REMARKS

Claims 1-32 are pending. Claims 20, 23 and 30 have been amended. Applicants respectfully request reconsideration of this application in light of the claim amendments and the following remarks.

FIGURE 1
PRIOR ART

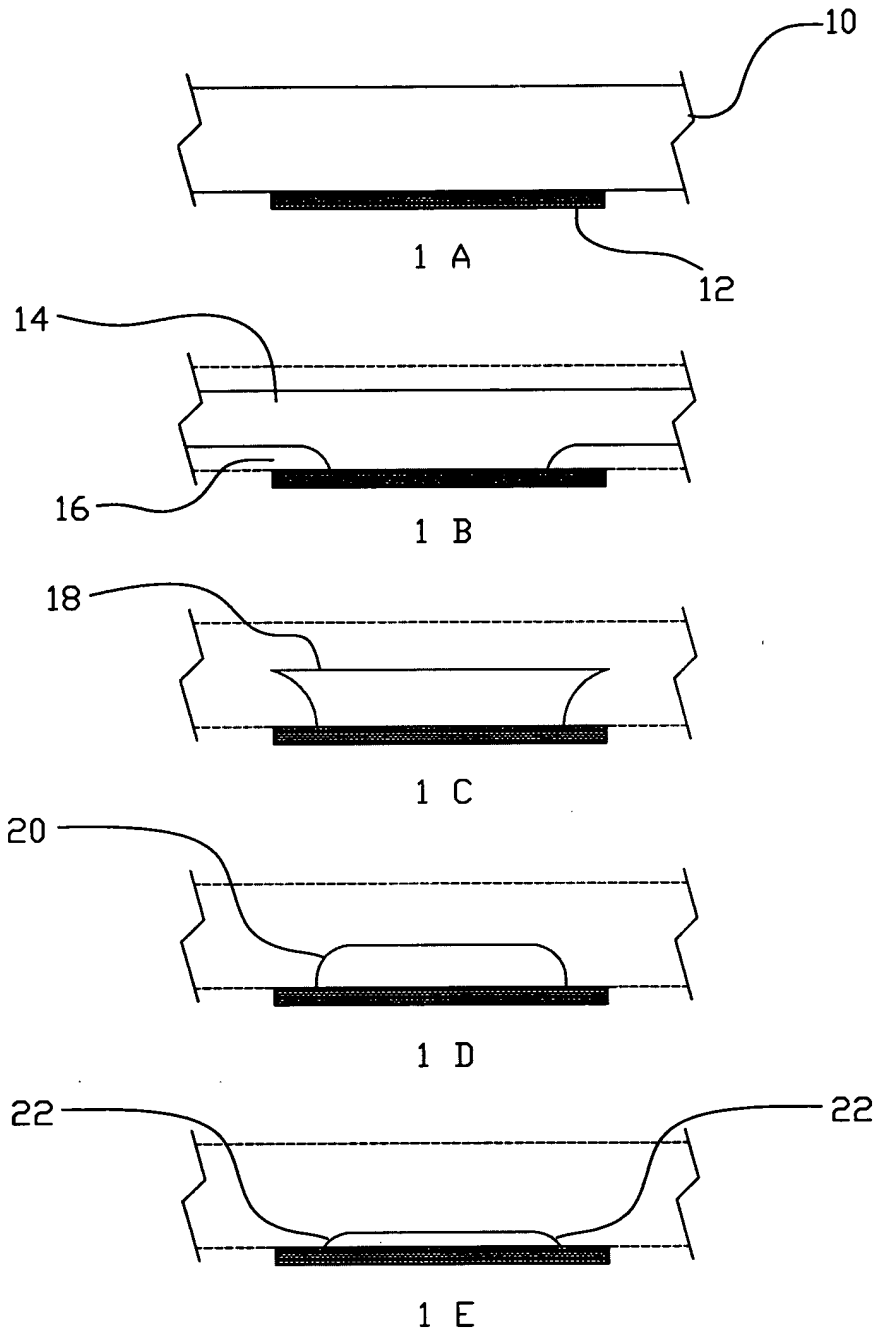
Fig. 1 was objected to for not including a "Prior Art" legend. Clean and marked-up copies of Amended Fig. 1 are included with this Amendment.

A "Prior Art" legend has been added to the identification of Fig. 1.
